Vendôme Project

Action plan in Response to the
Recommendations Issued in the Public
Consultation Report

October 2017

5. MUHC access by bus during the work

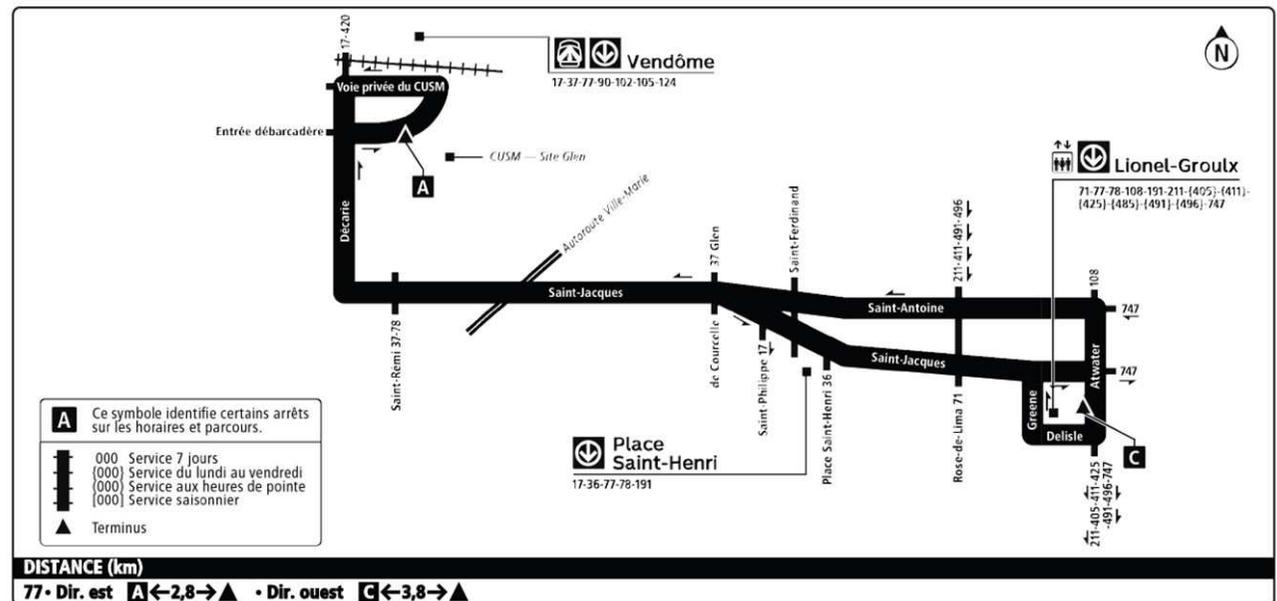
Recommendations	Actions
<p>5. The Commission recommends that, as a mitigation measure during the work, access to the MUHC by bus be improved for reduced mobility users whose transit time is unduly lengthened by Line 77. Examples of improvements were given during the consultation: the addition of a Line 77 stop at the Vendôme métro or the deployment of a shuttle. The Commission has no preference, but considered this improvement should be planned as a mitigation measure during the work and reevaluated afterwards.</p>	<p>After analysis of this request, it is undesirable to extend Line 77 Lionel-Groulx Station-MUHC to the Vendôme station or deploy a shuttle during the work, because the addition of a line to this terminus, which is already at full capacity, would cause operational issues for the existing bus lines (availability of platforms in the loop). Also, based on the mobility analyses, it was found that adding a stop at the Vendôme station would not be interesting for most customers, because no time would be gained. The trip would be more complex and longer, both for the current customers of Line 77 Lionel-Groulx Station-MUHC and for the customers from other lines or the métro.</p>

- Addition of a stop on Line 77 Lionel-Groulx Station-MUHC at the Vendôme station or deployment of a shuttle
 - After analysis of this request, it is undesirable to extend Line 77 Lionel-Groulx Station-MUHC to the Vendôme station or deploy a shuttle during the work, because the addition of a line to this terminus, which is already at full capacity, would cause operational issues for the existing bus lines (availability of platforms in the loop). Also, based on the mobility analyses, it was found that adding a stop at the Vendôme station would not be interesting for most customers, because no time would be gained. The trip would be more complex and longer, both for the current customers of Line 77 Lionel-Groulx Station-MUHC and for the customers from other lines or the métro.

OPTION 1: Integration of a collection area

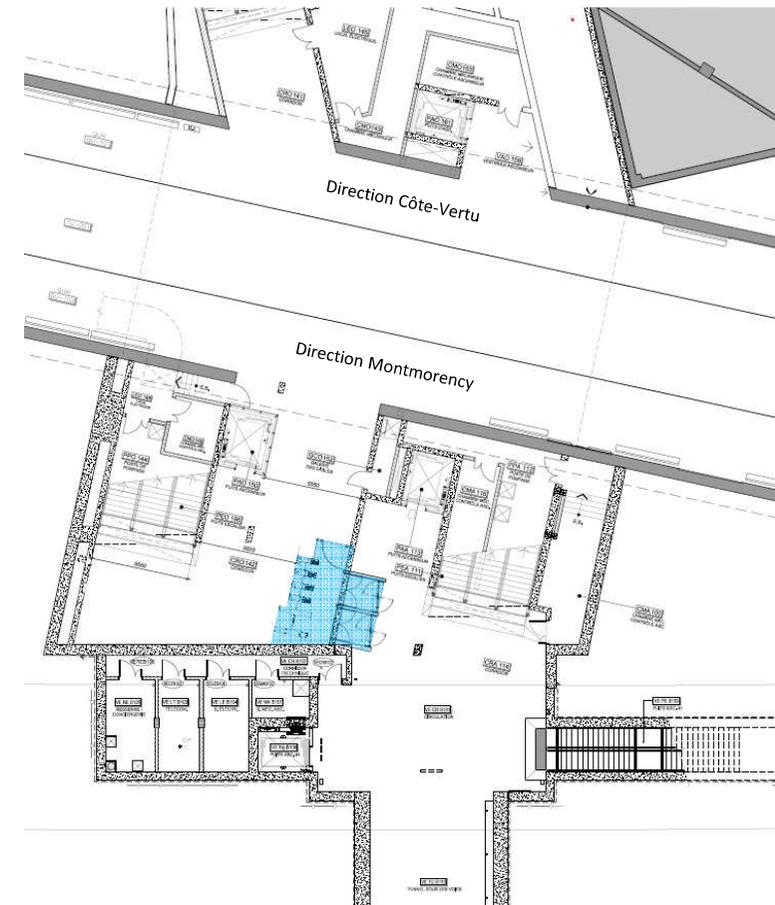
<p>6.1 The Commission recommends that the STM reread the construction plans in order to evaluate the feasibility of removing the wall in the tunnel separating the controlled part of the métro station from the uncontrolled part coming from the RTM and to provide for an exit turnstile and, if possible, one or more métro access turnstiles (without a fare booth) to allow quick direct access from and to the eastbound métro platform, and thus avoid the requirement for RTM users to climb up to the métro entrance and then go back down into the station.</p>	<p>A first analysis was conducted to evaluate the feasibility of creating this link as an official exit. Considering the issues of compliance with the standards in force and to ensure safe mobility, this option could not be chosen.</p> <p>A second analysis then was conducted to evaluate the possibility of integrating an exit door, to mitigate a situation of unavailability of the elevator on the Montmorency platform (power failure, breakdown, etc.). This option is not recommended for reasons of access control and incident management (fire, smoke, etc.) between the neighbouring facilities (STM/RTM).</p>

6.1 Remove the wall separating the STM from the RTM

- The possibility of integration of a collection area on the Montmorency platform level to mitigate a situation of unavailability of the elevator on at that location (power failure, breakdown, etc.) was analyzed.

- Several issues were noted:
 - Safety: evacuation problem in case of an event; insufficient space to integrate the number of turnstiles required and the clearances required between equipment;

- Ventilation of the collection area could not serve as an exit during evacuation, due to smoke control issues;
 - Piston effect: control of the piston effect problematic for the MUHC (management of air quality [microbes] versus vulnerability of its clientele);

- Operation: flow problems due to the insufficient number of turnstiles, creating a traffic bottleneck (intersection of STM / RTM entrances). This bottleneck will cause a wait time for customers and may extend as far as the platform, increasing the risks of train service stoppage.

6.2 Integration of escalators

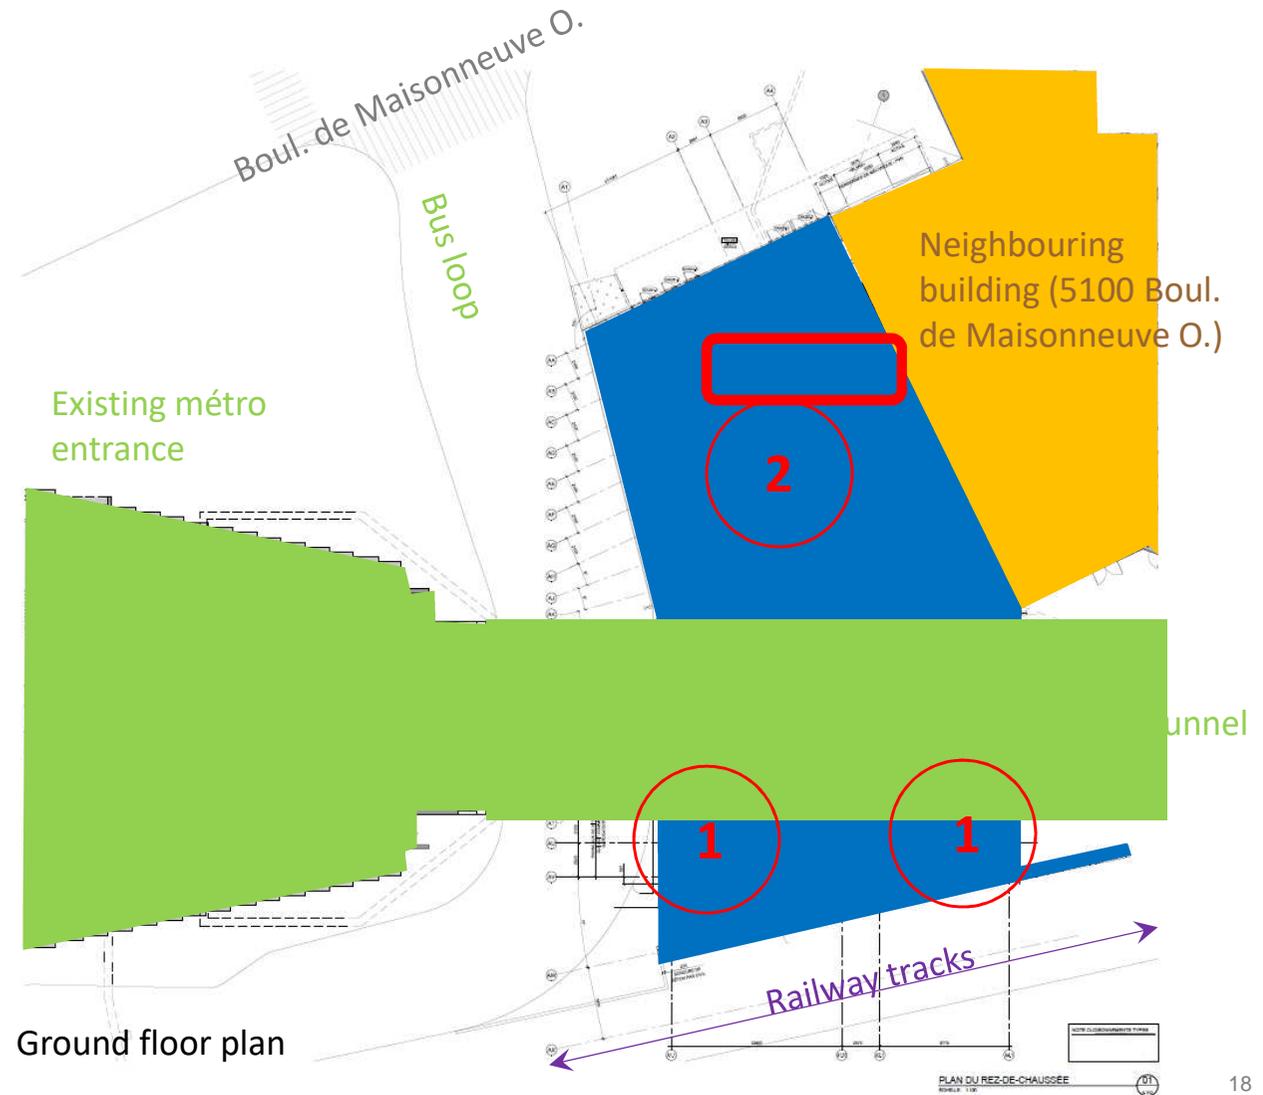
Recommendations	Actions
<p>6.2 The Commission recommends that the STM reread the construction plans to evaluate the feasibility of adding escalators wherever possible.</p>	<p>Given that the new entrance is enclosed between the 5100 Boul. de Maisonneuve O. building, the bus loop and the existing entrance, the métro tunnel and the railway tracks (including the projected 4th track), it is impossible to install escalator mechanisms without affecting the structural integrity, the necessary métro clearance (impacts on flow) and the evacuation capacity, without compromising CP requirements and the safety of the railway right of way.</p>
<p>7.1 Given the residential nature of the neighbourhood, the anticipation of a substantial increase in ridership and the inconveniences related to the construction work, and to improve the station's intermodality, the Commission recommends that the STM, the Côte-des-Neiges – Notre-Dame-de-Grâce borough and the MUHC, if applicable, work together to develop a drop-off zone for motorists who drive users to Boulevard de Maisonneuve Ouest across from the current entrance, in an "indentation" in the sidewalk, which is very wide at this location.</p>	<p>An analysis was conducted jointly with the CDN-NDG borough to study the feasibility of this recommendation, particularly regarding road traffic on Boulevard de Maisonneuve and the bus stop at this location. The development of a drop-off zone is impossible without compromising bus service and the current traffic conditions on Boul. de Maisonneuve.</p>

- The new Vendôme entrance is enclosed between the 5100 Boul. de Maisonneuve Ouest building, the bus loop and the existing entrance, the métro tunnel and the railway tracks (including the projected AMT 4th track).

7.1 Develop a drop-off zone for motorists

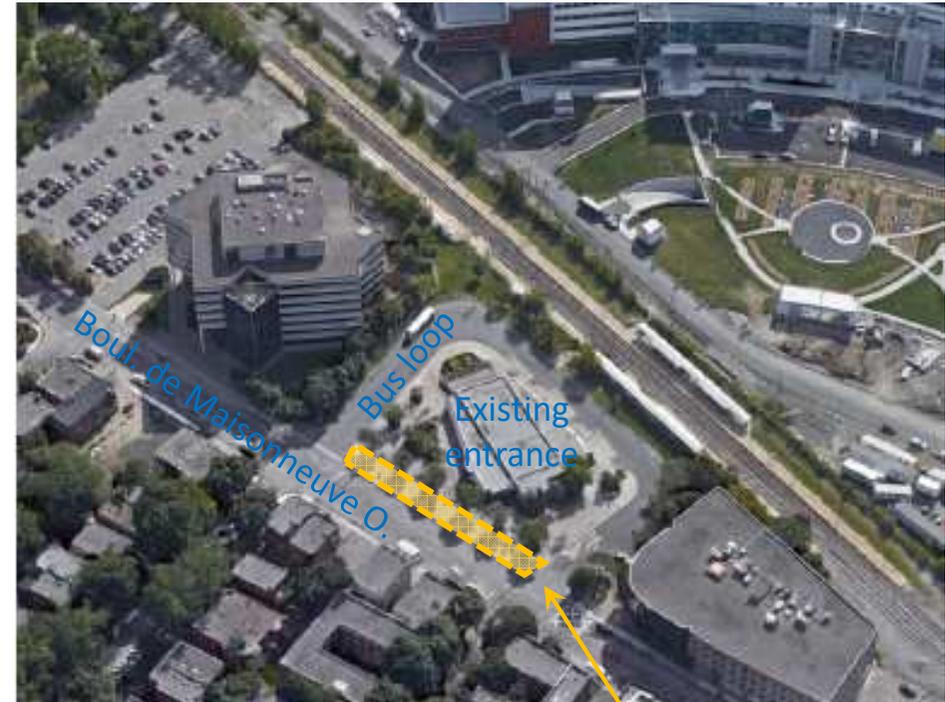
Requested drop-off zone

- An analysis was conducted jointly with the CDN-NDG borough to study the feasibility of this recommendation, particularly the road traffic level on Boulevard De Maisonneuve and the bus stop at this location. The development of a drop-off zone is impossible without compromising bus service and the current traffic conditions on Boulevard de Maisonneuve.

Vegetation plan

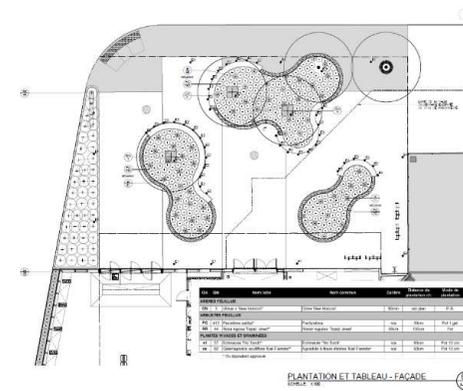
11. Urban furniture and vegetation plan

- Existing urban furniture included in the project:
 - Existing benches along the bus loop, at the existing entrance;
 - Integration of benches into the landscaping of the public square at the facade of the new entrance;
- Vegetation plan integrated into the project:
 - Planting zones at the building facade, in the public square;
 - Planting at the end of the bus loop, along the glassed facade;
 - Planting vines at the base of the crash wall;
 - New building with a green roof.
